Subject: Response to Dual Cell Exemption Request for Additional Information

Reference: 1. Your Fax dated 19 July 2000

DUAL DRIFT TUBE ASSEMBLY LABEL

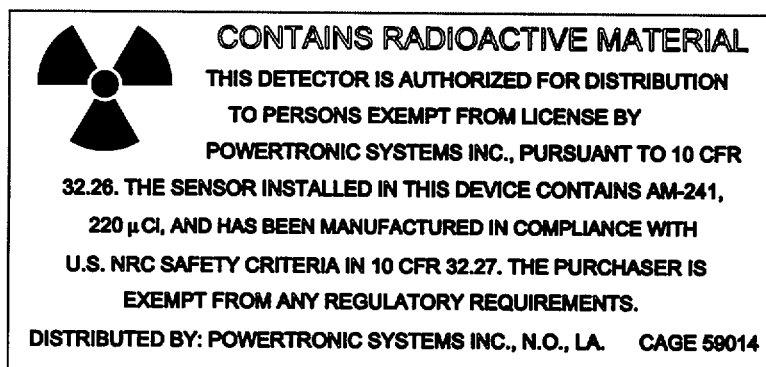
2. Change label text to reflect maximum device activity

See attached revised label drawing . Labels used will reflect the maximum cell activity of 220 μ Ci.
